SITE PLAN REVIEW

Project Name: hangars

FILE #SPR-96-230

TITLE HEADING: Airport Hangars

Date	10/17/96
Scale	20 scale
Drawn	JMK
Sheet	SP-1

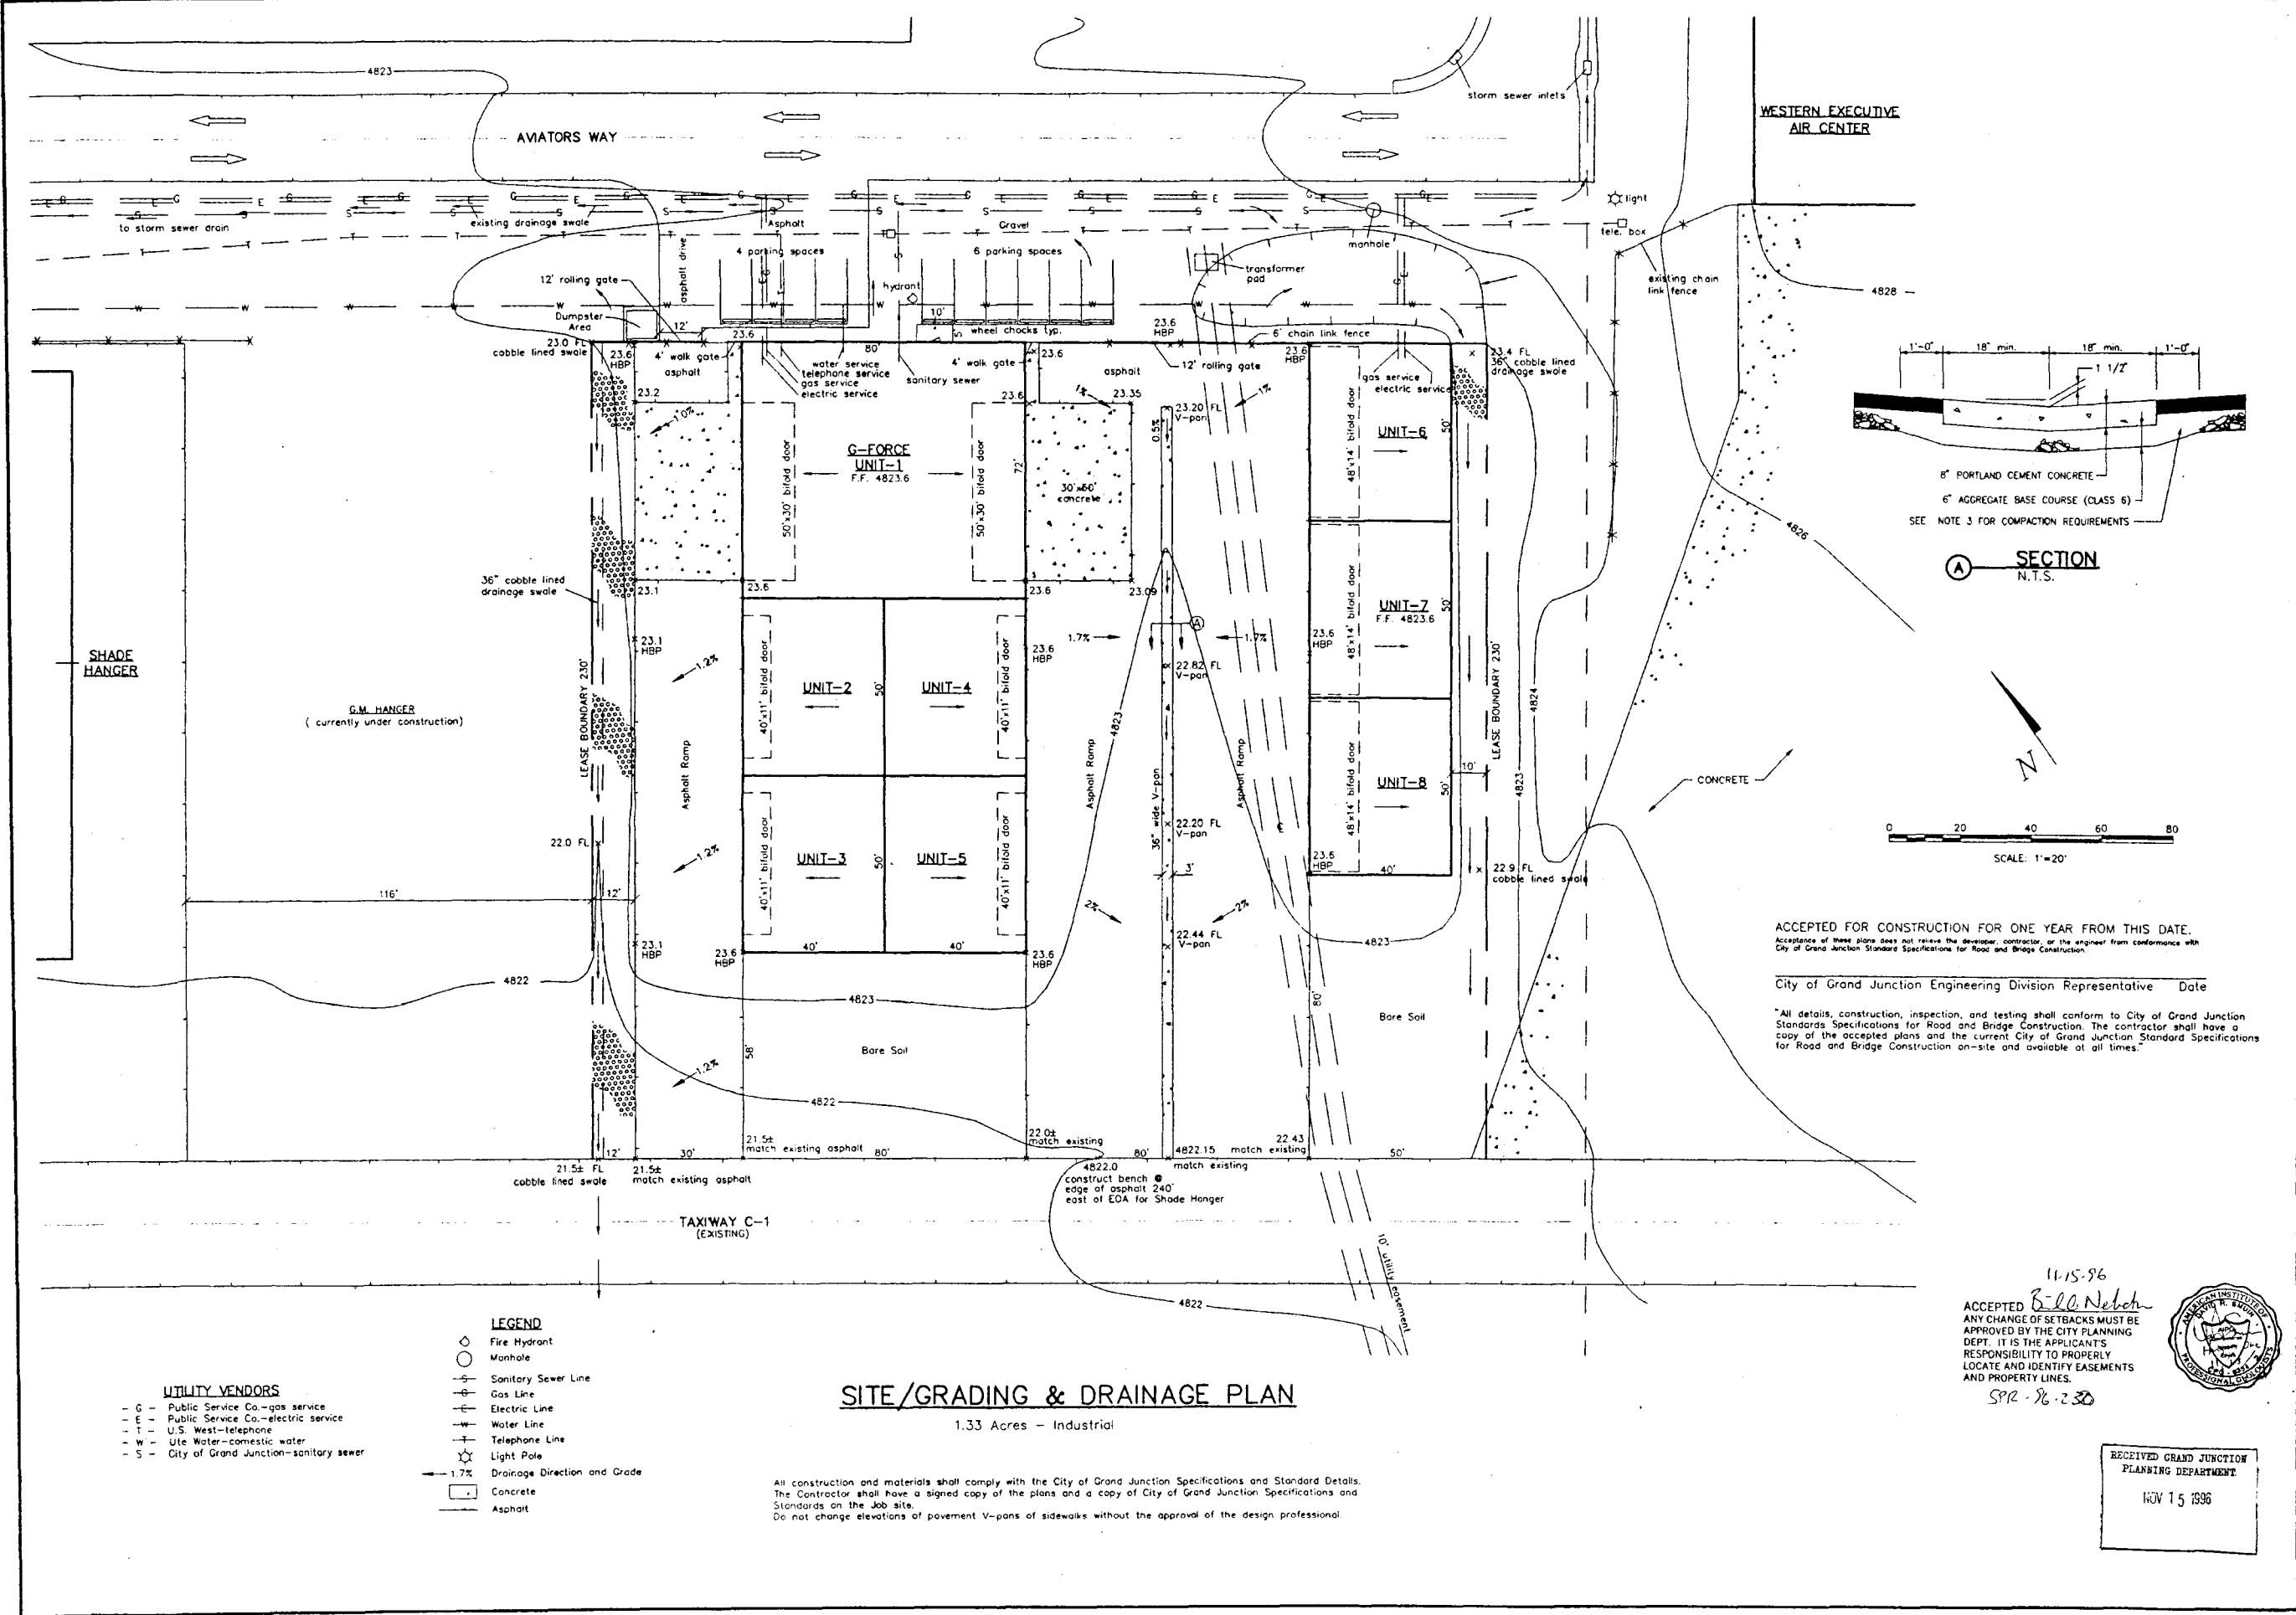
1. Required parking (at least 4 spaces) must be paved.
2. Isn't it more desirable to locate the landscaping in the front between the building and the hangars and include some trees?

1. Transportation Capacity Payment - \$480.00.
2. It appears based on the office space 4 parking spaces are required. The City Code requires all required parking and maneuvering areas, including the driveways, to be paved.

1. Trash, for the office space.....
2. Graveled areas - dust concern

Response: The plans have been changed to include 4 paved parking spaces along with paving the associated maneuvering areas and driveway.

Response: The plans have been changed to include 4 paved parking spaces along with paving the associated maneuvering areas and driveway.

Response: A dumpster area has been added to the plans
